Palisades Nuclear Plant
Docket 50-255
License No. DPR-20

Response to Request for Additional Information on Realistic Large Break Loss-of-Coolant Accident License Amendment Request (TAC No. MD3492)

ENCLOSURE 1
RESPONSE TO REQUEST FOR ADDITIONAL INFORMATION ON
REALISTIC LARGE BREAK LOSS-OF-COOLANT ACCIDENT

Figure 1-1 Sampled Core Power versus Peak Cladding Temperature

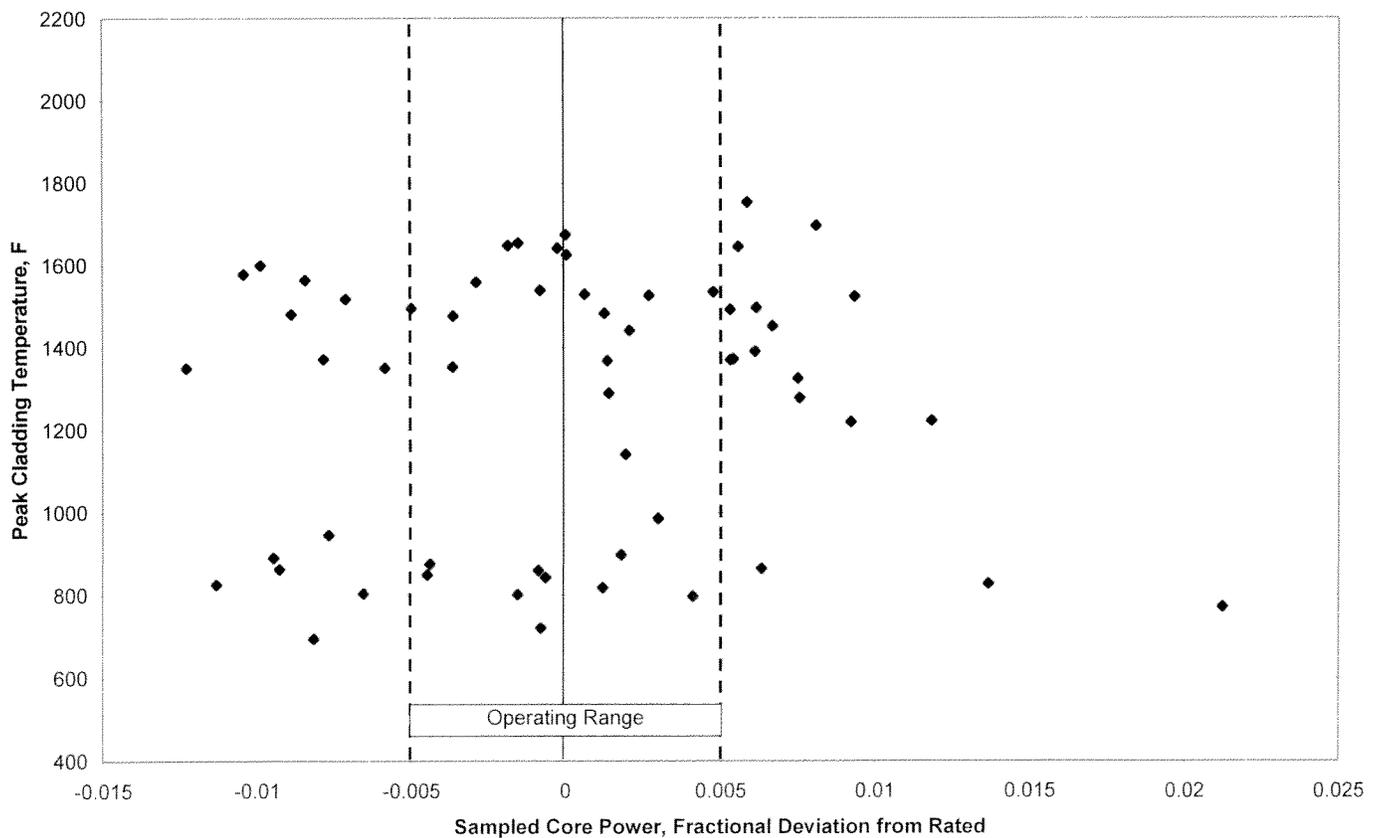
1. *Core Power Operation (%) - Table 3.3 [BAW-2501(P), Revision 2, page 3-12]. indicates that core power is ranged between 99.5% and 100.5%. The use of reactor power assumption other than 102%, regardless of BE or Appendix K methodology, is permitted by 10 CFR 50, Appendix K.I.A, "Required And Acceptable Features Of The Evaluation Models," "Sources of heat during the LOCA."*

What is the basis for deviating from 10 CFR 50, Appendix K.I.A?

What is the basis for power ranging? (That causes a conflict between two independent uncertainty profiles.)

1. The suggested requirement establishing the basis for the core power to be used in the analysis of PNP is Appendix K to 10 CFR 50.46. The LOCA analysis submitted is a statistically based evaluation for which the requirements of 10 CFR 50.46, Appendix K, Part I, do not apply. The method of establishing the core initial power for PNP was as specified in EMF-2103(P)(A), Revision 0, in accordance with the NRC approval of that methodology. Core power is sampled over the power operating range convolved with the core power measurement uncertainty.

The NRC issued Amendment 216 to the PNP operating license on June 23, 2004 (ML040970622), which approved a measurement uncertainty recapture power uprate. The PNP operating range is $\pm 0.5\%$ of rated power. Therefore, in the report, power is first sampled between 99.5% and 100.5% using a uniform distribution. The model power is then obtained by adjusting the nominal power by the PNP reduced measurement uncertainty, approximately 0.6%, based on a Gaussian distribution. Figure 1-1, provides a scatter plot of peak cladding temperature (PCT) as a function of fractional deviation from rated power. As can be observed, approximately half of the case set has a power below 100% and the other half above. However, because the Gaussian distribution for instrument uncertainty both increases and decreases the core power as sampled from the operating range, 76% of the assigned powers lie above the 99.5% lower boundary of the operating range. Two-thirds of the cases of the set have sampled core powers at or above 99.8% of rated power. Furthermore, the highest PCT occurs for a case with a core power of 100.6%.

**Figure 5-1 Film Boiling Heat Transfer Contribution – Forslund-Rohsenow Limit
Case 13, PCT Node 36, @ ~PCT Time (27s)**

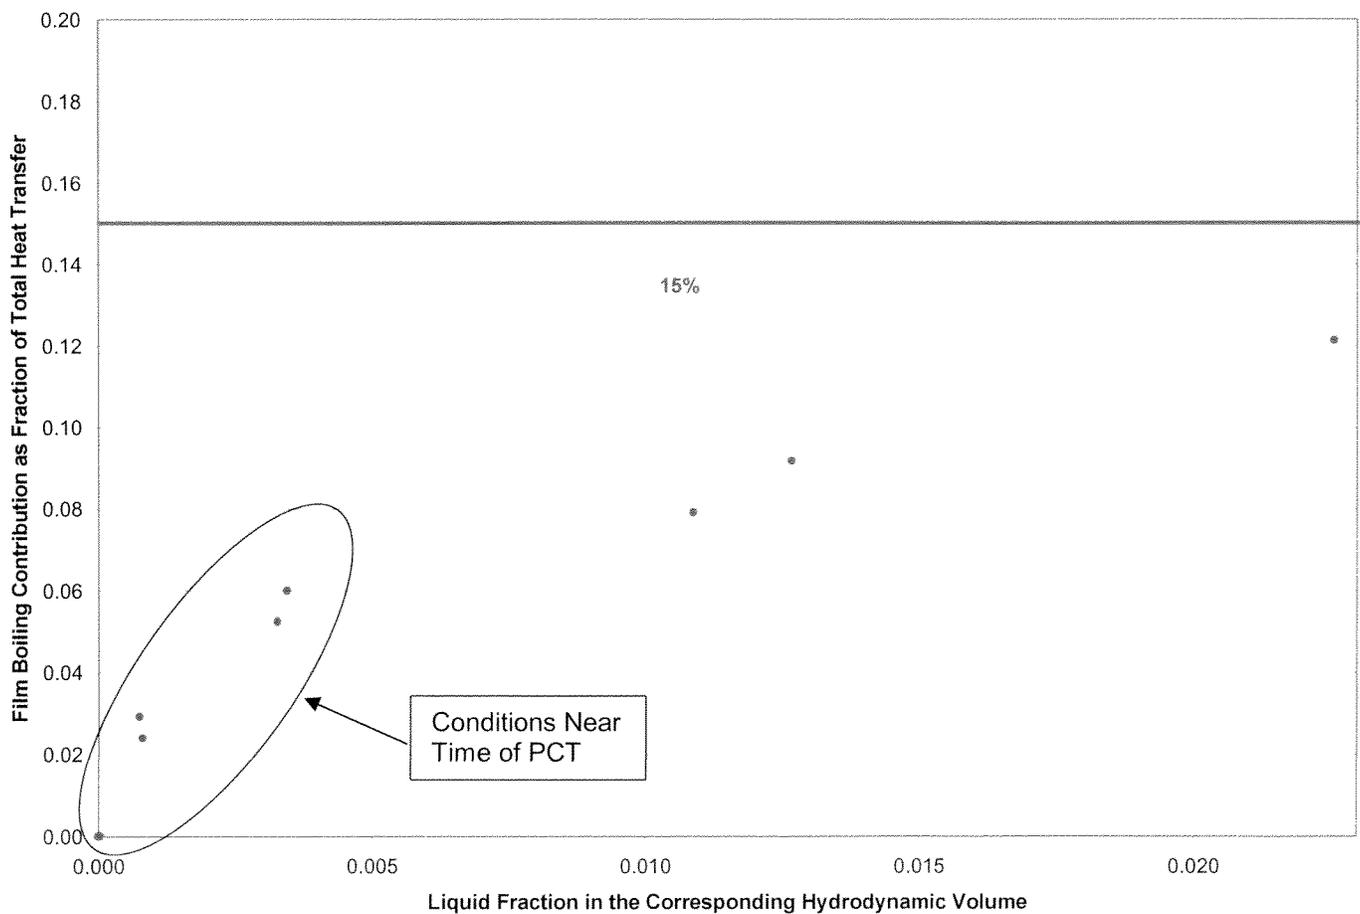
- 5. Is the Forslund-Rohsenow model contribution to the heat transfer coefficient limited to less than or equal to 15% when the void fraction is greater than or equal to 0.9?*

- EMF-2103(P)(A), Revision 0, does not require a limitation on the Forslund-Rohsenow heat transfer correlation. However, as a practical matter, the contribution of Forslund-Rohsenow to the total heat transfer package decreases as the local void fraction increases and is less than 15% for void fractions above approximately 97%. Figure 5-1 provides a scatter plot, taken from the limiting PNP case, of a sampling of the percentage of the Forslund-Rohsenow contribution to heat transfer as a function of liquid fraction. The sampling includes several points near the time of PCT (circled area). As expected, the fluid cooling the hot spot at the time of PCT comprises steam in transition to low liquid fraction. The contribution of Forslund-Rohsenow to the total heat transfer in such a flow is limited, and well below 15%. Thus, it can be concluded that there would be no direct influence of a limitation on Forslund-Rohsenow on the resultant limiting PCT for PNP.

An indirect effect on PCT may occur because such a limitation may reduce steam generation below the hot spot where the void fraction could reside between about 90% and 97%. Such an impact is expected to be small and, given that the limiting

PCT for PNP is 1751°F, well below the temperature (1800°F) at which local oxidation can become a complicating influence, does not pose a concern for the conclusions reached by the realistic large break LOCA evaluation.

In summary, there is no limitation of the contribution of Forslund-Rohsenow to the heat transfer for the PNP realistic large break LOCA analysis. However, the impact of such a limitation, if it were to be applied, would be minimal and would not lead to an alteration of the conclusions of the analysis that the cladding temperature and local cladding oxidation have been demonstrated to meet the criteria of 10 CFR 50.46 with a high level of probability.

Figure 8-2
PCT versus Initial Containment
Atmospheric Temperature

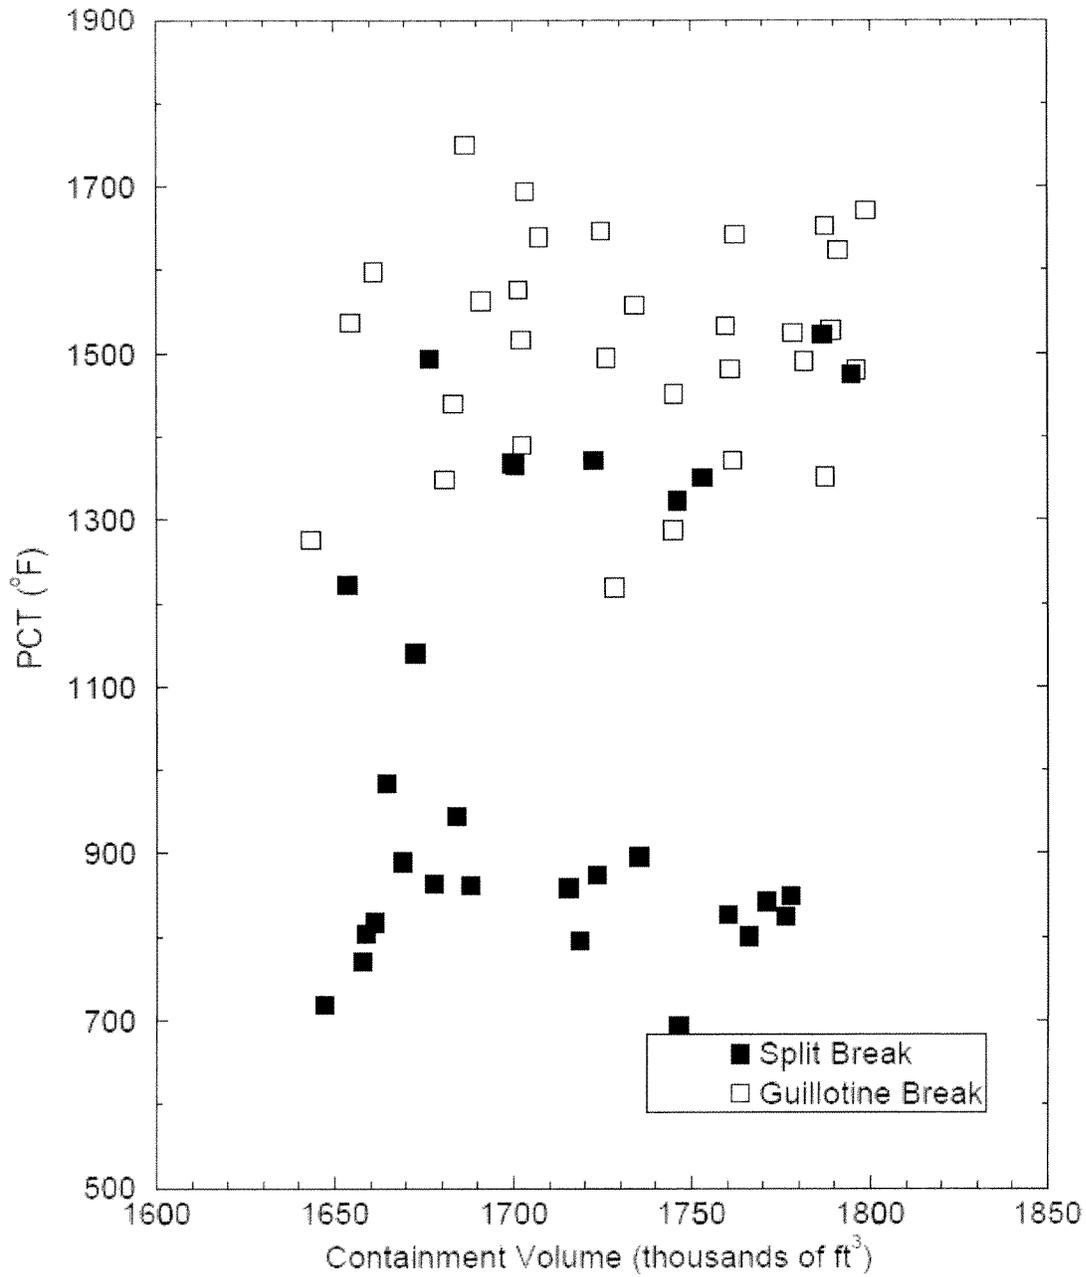
8. *EMF-2103, Revision 1 was withdrawn. Please identify the containment methodology that was used, and show that it is acceptable for use with EMF-2103, Revision 0.*

The sampling parameters that affect the containment response for a given case are the containment free volume and the initial containment atmospheric temperature. The containment free volume was sampled from a lower end value of 1.64 million ft³ to a maximum value of 1.804 million ft³ using a uniform distribution. The minimum value of 1.64 million ft³ is the volume used in the containment design pressure calculation. The upper end value of 1.804 million ft³ is the envelope available within the inner shell of the containment with all interior structures removed. The containment atmospheric temperature is ranged between the minimum and maximum values for containment temperature as set in the plant technical specifications. The initial building humidity is held constant across the case set at 100% in agreement with the NRC Standard Review Plan, Branch Technical Position 6-2, "Minimum Containment Pressure Model for PWR ECCS Performance Evaluation," Revision 3, for minimum containment pressure calculations.

The net effect is a set of containment pressure predictions that lie between a best estimate response and the full conservatism of a Branch Technical Position 6-2 model used for deterministic, Appendix K based LOCA evaluations. For PNP this is illustrated in the Figures 8-1 through 8-3. The first two are scatter plots of PCT versus the sampled containment volumes and initial atmospheric temperatures. Figure 8-3 is a plot of containment pressure versus time for the limiting case (13) which is also representative of large break cases with higher containment pressures, a case (17) representative of large break cases with lower containment pressures, and the containment pressure response for the reference Appendix K calculation.
